**PACIFIC AVIATION INVESTMENT PROGRAM (PAIP)**  
**TUVALU AVIATION INVESTMENT PROJECT (TvAIP)**  
**Supply and Installation Solar Street Lighting**  
**CONTRACT REF: MCT/SHPG/T-A29**

**AMENDMENT NO. 2 TO THE BIDDING DOCUMENTS**

**CLARIFICATION NO. 1 TO THE BIDDING DOCUMENTS**

1. Lighting Frames

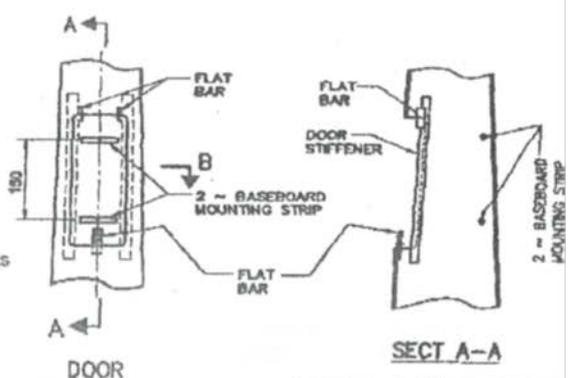
| No | Questions from Suppliers  | Action to be taken / Response  |
|----|---|--|
| 4  | Is the "Lighting Frame" a post top mount to   | The lighting frame is marked in red in   |

|   | attach the LED luminaire to an existing pole?   | the photo below.<br><br>   |
| 7 | Could you supply further information/specification/description for the 166 Lighting Frames? It is not clear exactly what these are.   | The 166 lighting frames are the top mount for LED but we call it frames. Please refer to the photo above.  |
| 8 | Please provide us with drawings for the required items:<br><ol style="list-style-type: none"> <li>1. Lighting Frames</li> <li>2. Posts</li> </ol>   | Please see below.  |

2. Post

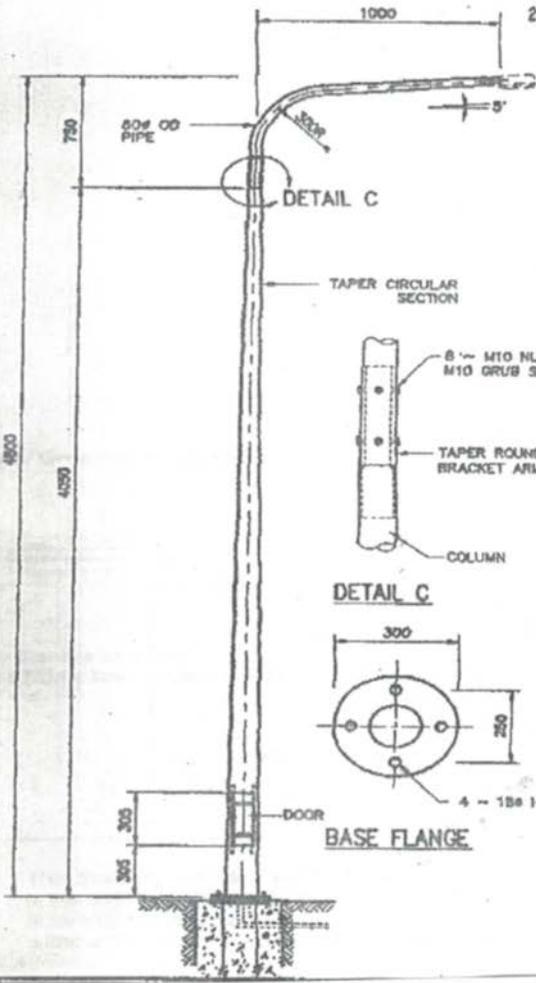
| 5 | Is the "Post and Frame" a new pole with post top mount for the LED luminaire? If this is the case can you please advise more details about the required pole? For example is it a tapered pole or a simple pipe pole and also do we assume that as there mention, in the documentation, of a 4m luminaire height that that is the required height for these new poles? What sort of base is required for these poles; are they to be direct buried or will they use a rag bolt base with concrete foundation? | <ol style="list-style-type: none"> <li>1. Post and Frame. This means a new post and new top mount for the LED luminaire as you called it but we called it Frame.</li> <li>2. Requirement for the new post <ul style="list-style-type: none"> <li>&gt;Design Condition</li> <li>- Maximum sail area:0.2m2</li> <li>&gt;Standard</li> <li>- Pole design – AS4100, AS 1170</li> <li>- Material – AS 1594 or Equivalent</li> <li>- Galvanizing – AS1650</li> <li>-Height – 4800mm</li> <li>- Door – 610mm</li> <li>- Base Flange – 4 ~180</li> <li>-4 only M16 X 70 Galv, Gr. 4.6 Bolt/Nut/Washer</li> </ul> </li> </ol> |

APPLY SPEC 2400242

1.2 MAXIMUM SAIL AREA : 0.2 m<sup>2</sup>

- 2.1 POLE DESIGN : AS 4100, AS 1170
- 2.2 MATERIAL : AS 1594 or EQUIV.
- 2.3 WELDING (ELECTRIC ARC WELDING) : AS 1554
- 2.4 GALVANIZING : AS 1650
